SUTTON CONSERVATION COMMISSION

February 19, 2014

MINUTES

SITE PLAN
SCALE: 1" = 40'

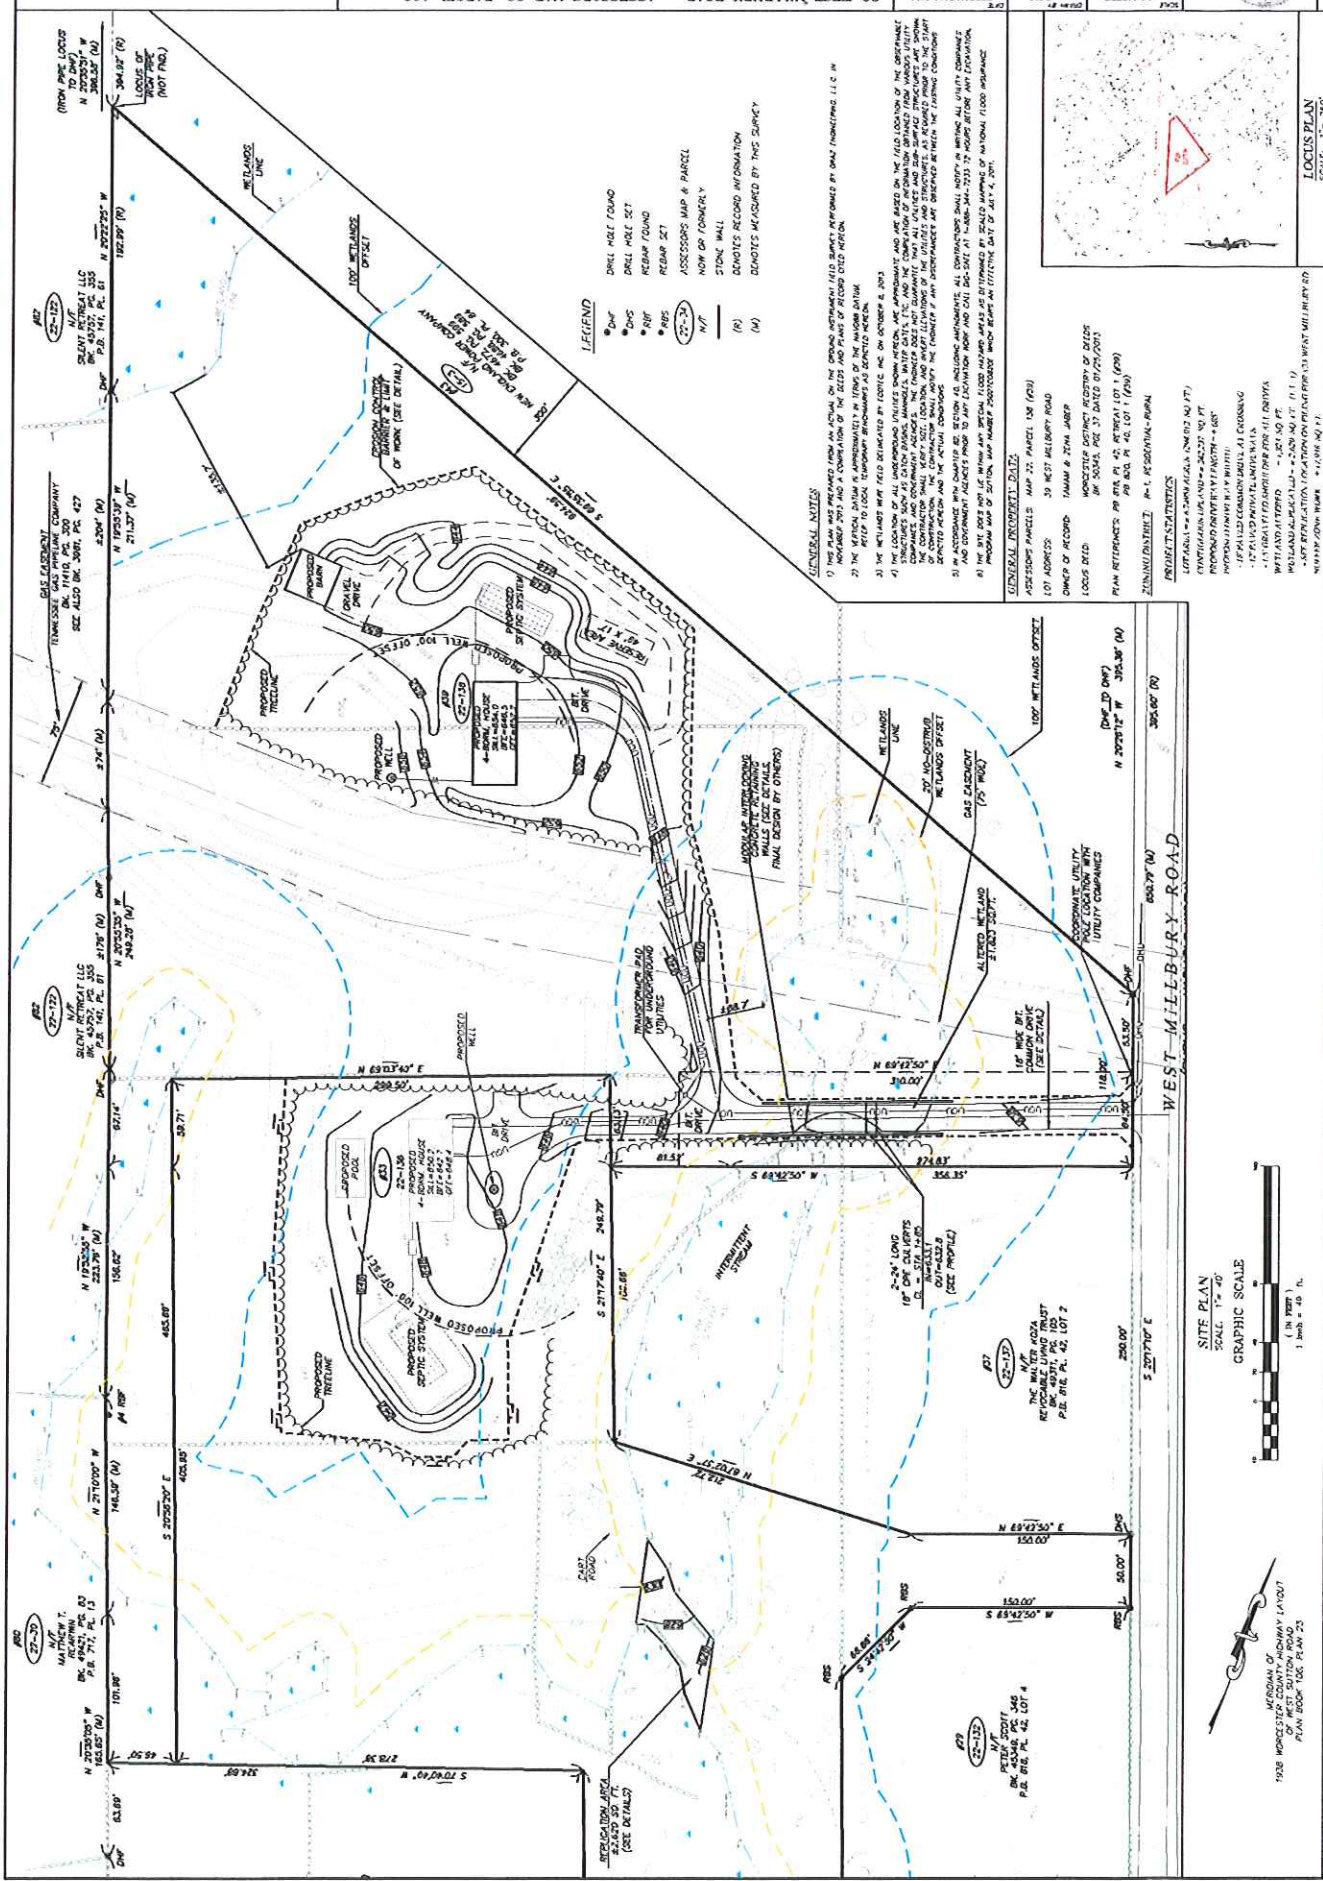
1. Due to heavy snow cover, an analysis of the wetland resource area types, boundaries and wildlife habitat could not be made. All comments made below are dependent upon these analyses. The hearing must be continued to allow for snow melt so I can perform an adequate analysis of wetland flagging and wildlife habitat. Further, the project is being reviewed by Planning Board, NHESP, and Tennessee Gas. Their comments may affect the project as currently proposed.
2. Once NHESP review is complete, please depict all areas under Conservation Restriction on the site plan.

4. A defined Limit of Work must completely encompass areas of permanent, temporary, and/or limited alteration (see Section 7.1.1-7.1.4) with no open ends. This includes a line that goes all the way around the house. Separating permanent from temporary or limited disturbance areas is crucial.
5. Will permanent signage be required as part of the Conservation Restriction? If so, add them as part of the plan. If not, signage is recommended at the LOW adjacent to wetland resource areas and/or in the AURA.
6. Label areas of permanent Conservation Restriction per NHESP.

7. I recommend use of silt fence, at least 5' from the base of slopes that are $\geq 10\%$. Otherwise, erosion controls may consist of straw wattles large diameter straw wattles or mulch soxx, with 100% biodegradable sheathing, with a backing of orange snow fence. Amend the site plans with appropriate erosion barrier details, especially to show that sheathing must be 100% biodegradable and without fixed diameter openings (e.g. burlap sheathing or natural rope with movable openings to prevent wildlife entrapment).
8. "Critter passes" may be eliminated if silt fence is not used.
9. Depict dedicated stockpile areas, with erosion controls on the downhill side.
10. Depict controls for roof runoff, along with any details (e.g. drywell).

11. How much more BVW disturbance would be created if retaining walls were eliminated? Would it exceed the 2,620sf that is part of the replication? A grassed slope would facilitate small wildlife movement better than a retaining wall, and would be less expensive.
12. Silt fence should be prohibited in any area that would be perpendicular to flow in the BVW.
13. Outline stockpile areas with appropriate erosion controls.

14. The plans also depict Lot 136, which although related via the common driveway, is not part of the subject application. The problem involves having a plan of record on file that depicts work on both lots, when this OOC only covers Lot 138. It will create confusion and potential legal problems in the future. I recommend an overall subdivision/site plan that depicts the relationship between the two, either on a different sheet, or as an insert on the existing plan. But I recommend maintaining the plan view on Sheet 1 to show only work on Lot 136, and thereby separating the two applications. Any details relating to the crossing can be eliminated on Sheet 2. **One suggestion is to outline the work on Lot 136 in light gray, as opposed to black, and to make a note on Lot 136 that reads: (See DEP file no. 303-0777).**

15. State the general sequence of work as notes on the site plan.

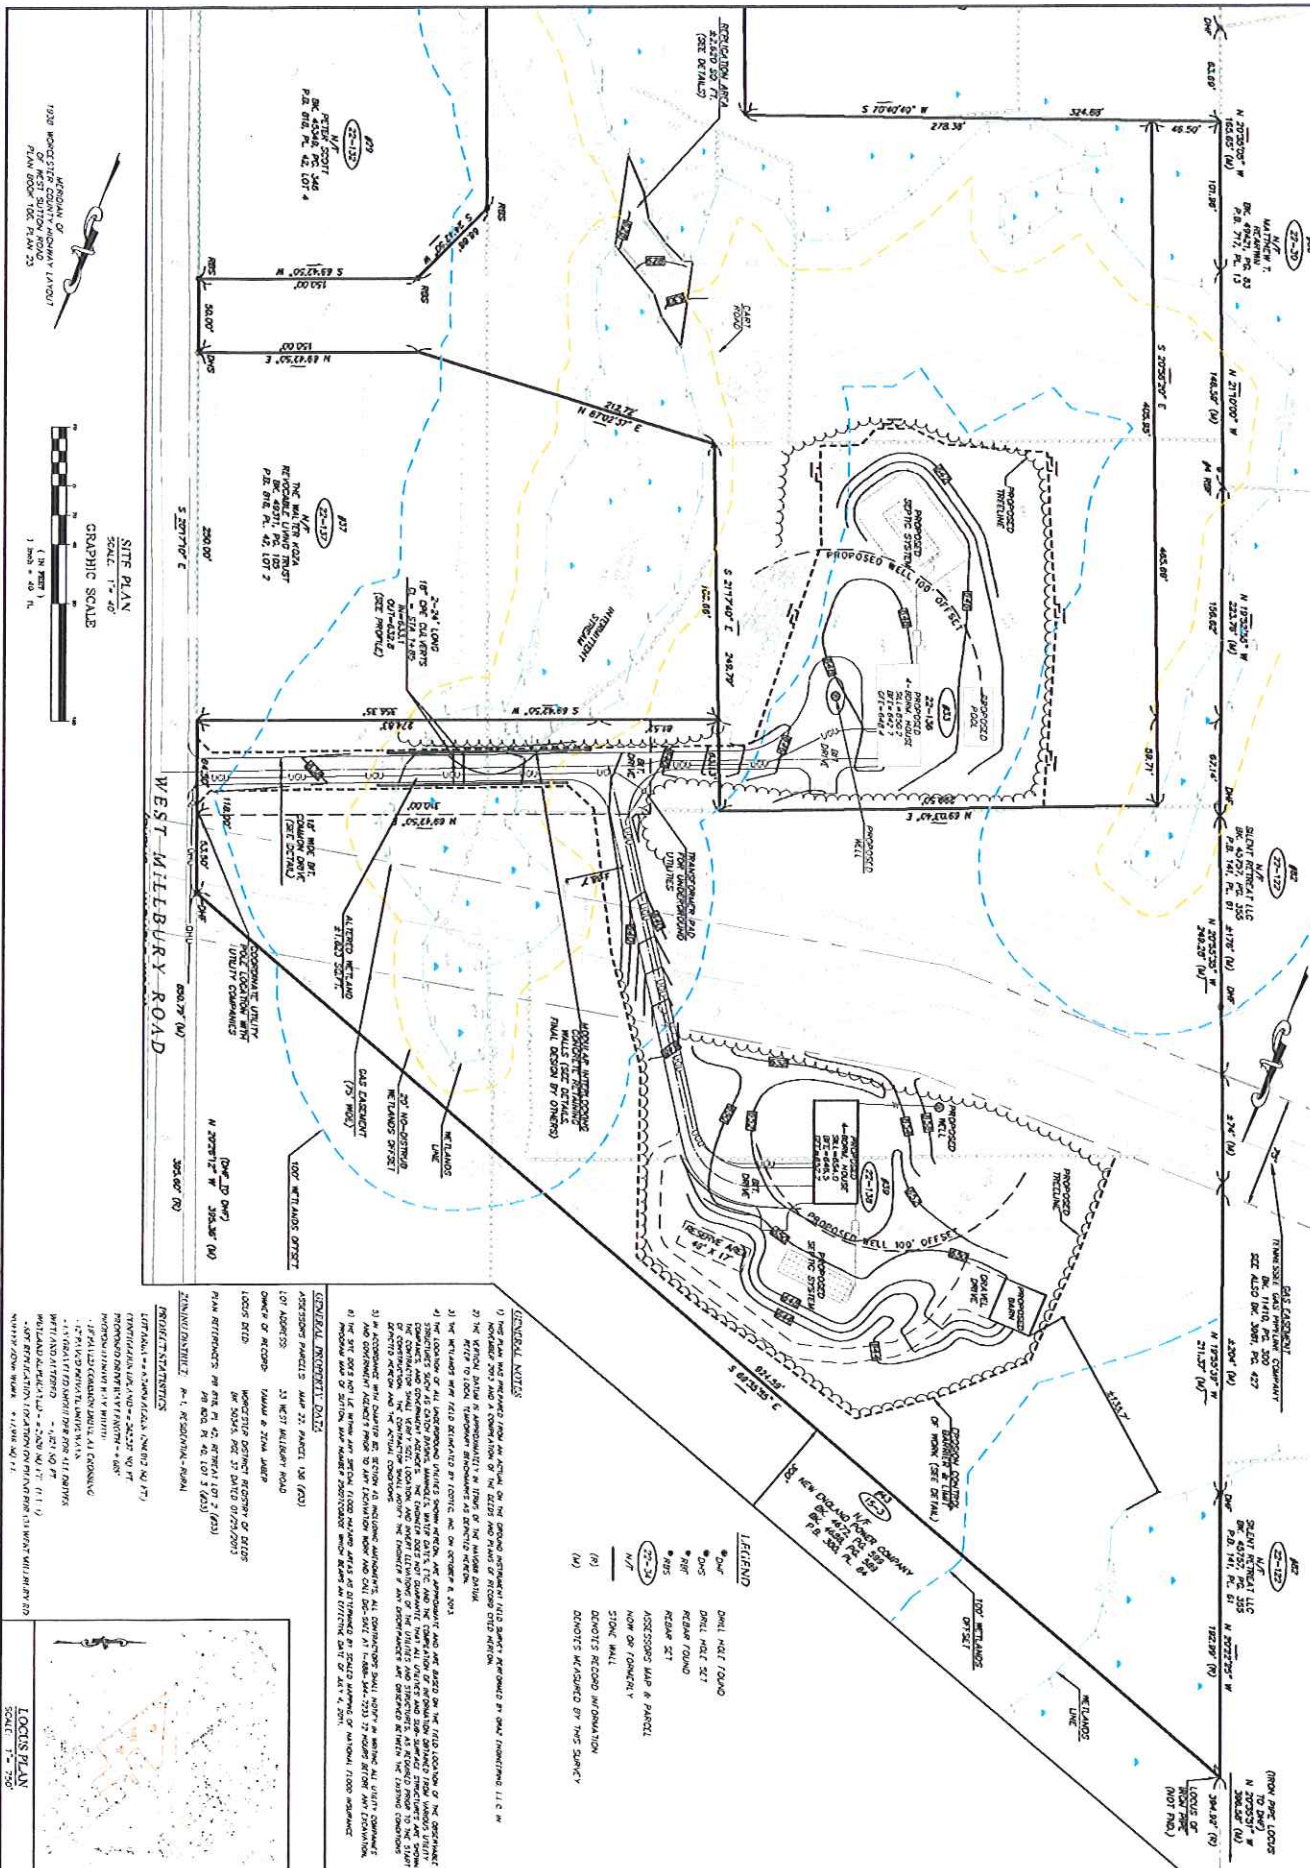
18. The plans also depict Lot 138, which although related via the common driveway, is not part of the subject application. The problem involves having a plan of record on file that depicts work on both lots, when this OOC only covers Lot 136. It will create confusion and potential legal

problems in the future. I recommend an overall subdivision/site plan that depicts the relationship between the two, either on a different sheet, or as an insert on the existing plan. But I recommend maintaining the plan view on Sheet 1 to show only work on Lot 136, and thereby separating the two applications. Any details relating to the crossing can be eliminated on Sheet 2.

19. Re-name the 'Replication Area' callout as 'Replication for permanent alteration to BVW via common driveway on Lot 138. (see DEP File no. 303-0776.)'

20. State the general sequence of work as notes on the site plan.

21. What will be the ultimate, permanent state of the cart road on either side of the replication area within jurisdictional areas?

NOTICE OF INTENT PLAN
PREPARED FOR: TAMAM & ZENA JABER

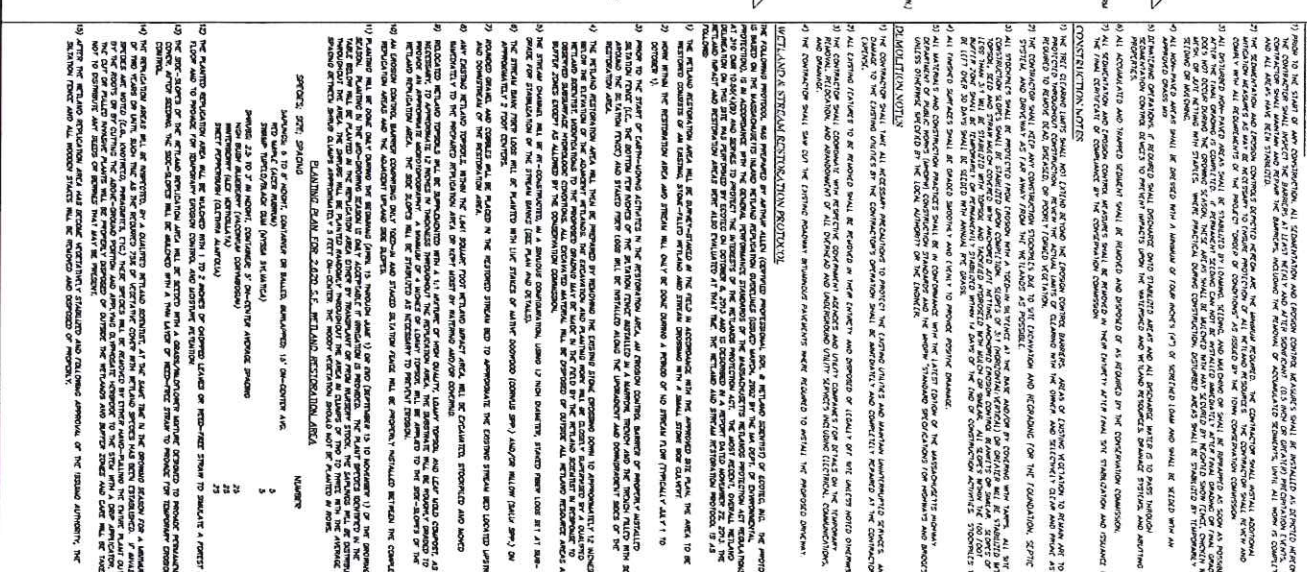
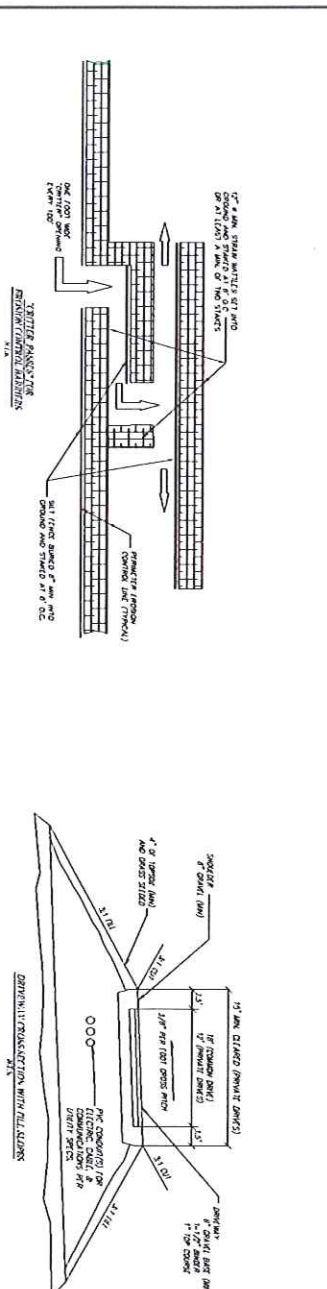
4. In the northwest corner of the yard, state the necessity for yard within the 100' AURA, and what measures have been employed to mitigate for such alterations. An analysis of the forest cover/habitat may be necessary to determine adequate mitigation measures.

5. On the eastern side of the house, and presuming the area within the LOW will be maintained as permanent lawn, state the need for permanent lawn. Also state the need for perimeter fill around the septic system within the AURA (i.e. why the AURA could not be avoided). If the area is to be permanently maintained, mitigation must be proposed for impacts within the AURA.

6. A defined Limit of Work must completely encompass areas of permanent, temporary, and/or limited alteration (see Section 7.1.1-7.1.4) with no open ends. This includes access to the replication area in addition to other areas currently within the proposed tree-line. Separating permanent from temporary or limited disturbance areas is crucial.
7. Will permanent signage be required as part of the Conservation Restriction? If so, add them as part of the plan. If not, signage is recommended at the LOW adjacent to wetland resource areas and/or in the AURA.

13. As mentioned above in Comment 8, silt fence in the channel, or any area perpendicular to flow, should be prohibited. Amend Comment 3 appropriately.
14. Depict erosion controls in area of wetland replication on Sheet 1.
15. In conjunction with Comment 11 above, outline stockpile areas with appropriate erosion controls in relation to Protocol Comment 9.
16. I recommend a less ubiquitous shrub than sweet pepperbush to compliment highbush blueberry and winterberry. Please amend Comment 11 appropriately.
17. Per Comment 12, it is imperative that any chopped leaves or straw used on the floor of the replication area be weed free.
